DEVELOPMENT NO.:	24002719
APPLICANT:	Tom Vartzokas
ADDRESS:	98 ESPLANADE HOVE SA 5048
NATURE OF DEVELOPMENT:	Variation to development application 22026449 comprising the construction of a roof top terrace as a 4th building level
ZONING INFORMATION:	<p>Zones:</p> <ul style="list-style-type: none"> • Waterfront Neighbourhood <p>Overlays:</p> <ul style="list-style-type: none"> • Airport Building Heights (Regulated) • Affordable Housing • Building Near Airfields • Coastal Flooding • Prescribed Wells Area • Regulated and Significant Tree • Stormwater Management • Urban Tree Canopy <p>Technical Numeric Variations (TNVs):</p> <ul style="list-style-type: none"> • Finished Ground and Floor Levels (Minimum finished ground level is 3m AHD; Minimum finished floor level is 3.25m AHD) • Minimum Frontage (Minimum frontage for a detached dwelling is 5m; semi-detached dwelling is 5m; row dwelling is 5m; group dwelling is 5m; residential flat building is 5m) • Minimum Site Area (Minimum site area for a detached dwelling is 300 sqm; semi-detached dwelling is 250 sqm; row dwelling is 200 sqm; group dwelling is 200 sqm; residential flat building is 200 sqm) • Maximum Building Height (Levels) (Maximum b

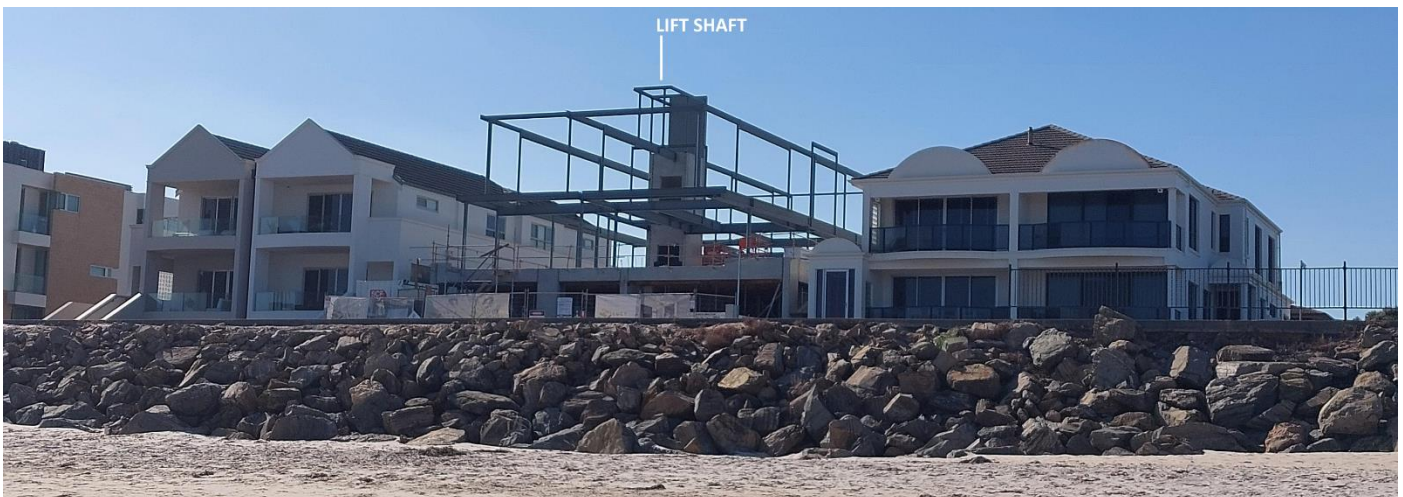
It is noted however that the nearby locality contains predominately 3 and 4 level buildings (4 levels being similar in form comprising roof top lift shafts, equipment enclosures and the like). The proposed building height therefore is complementary to nearby built form, specifically 87, 92 and 96 Esplanade, as seen in the photo below:

Although the 4th levels are prominent when viewing the other existing buildings, the overall scale and visual form is not so dominate as to read as conventional 4 level dwellings when generally viewing the buildings from the footpath. The 4th level components in effect, are largely obscured and of a scale no greater than if those buildings had been approved with pitched gable or hipped roofs.

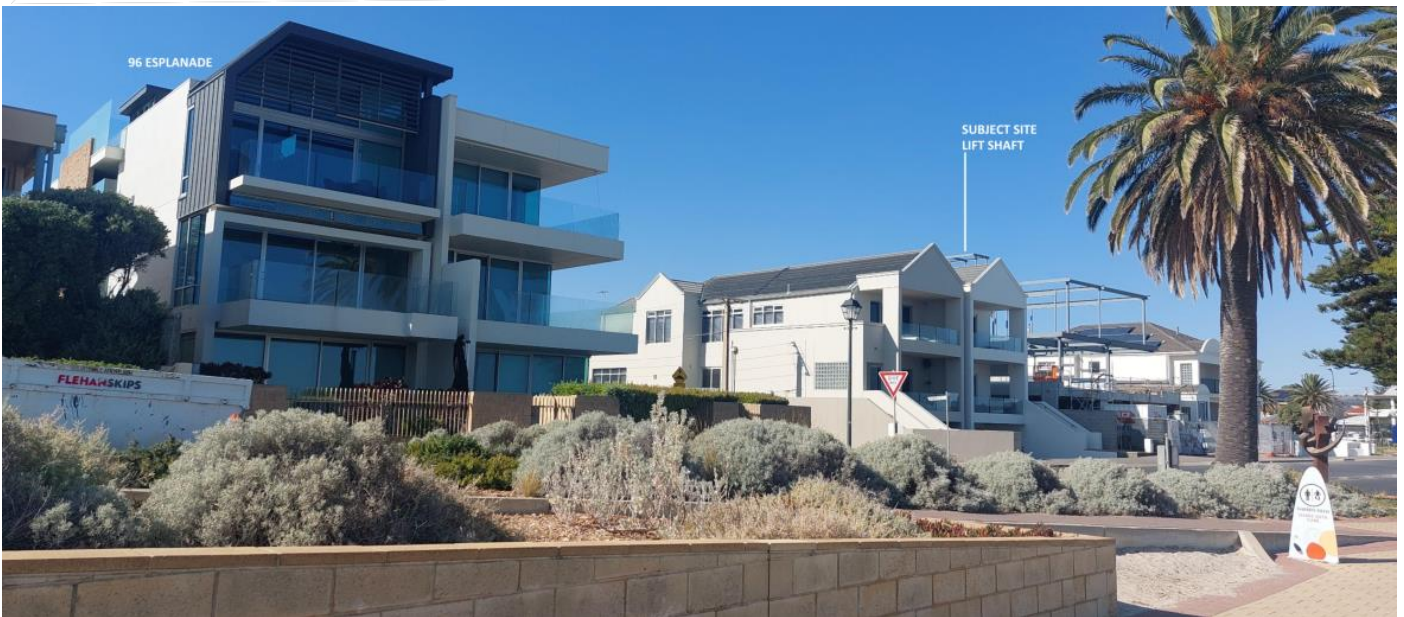
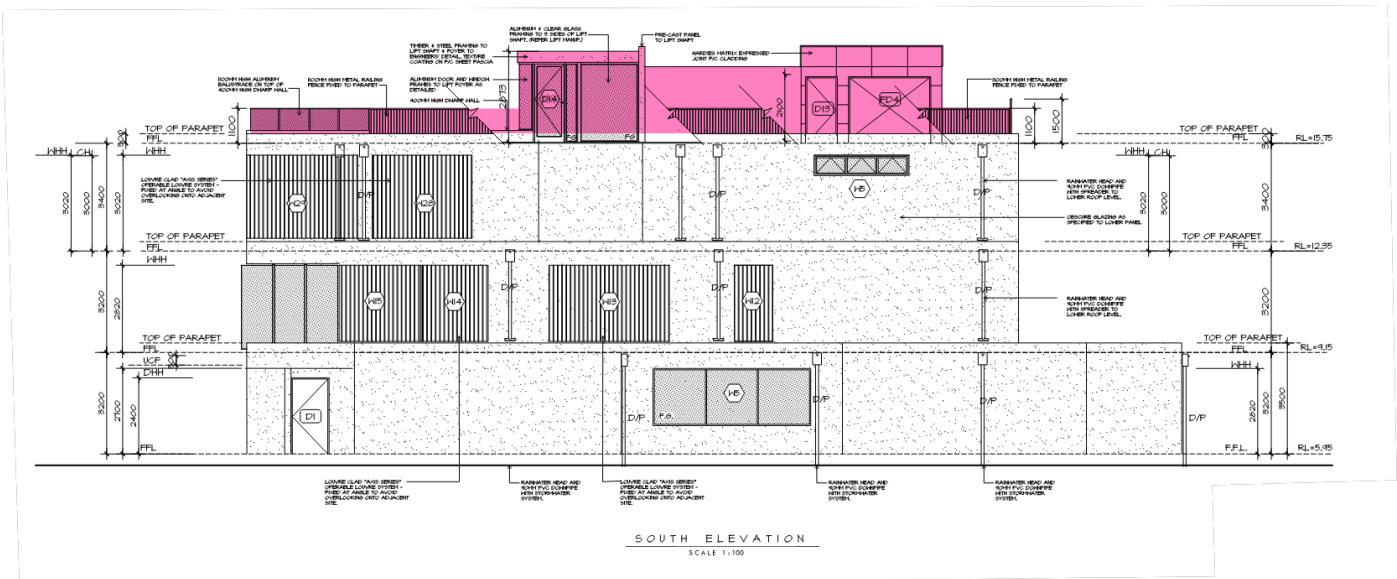
Regarding the subject building, when standing on the beach, for example, which offers a greater vantage point of the building, the lift shaft is visible, however the extent of walling beyond will be obscured by the overall height of the approved building facade:

The additional building level however will be visible from adjacent properties, such as behind the site, as demonstrated in the photo below. Overall, the existing approved building will obscure much of the 4th level wall, as per the vantage points from the street, however there will remain additional building scale visible from adjacent sites.
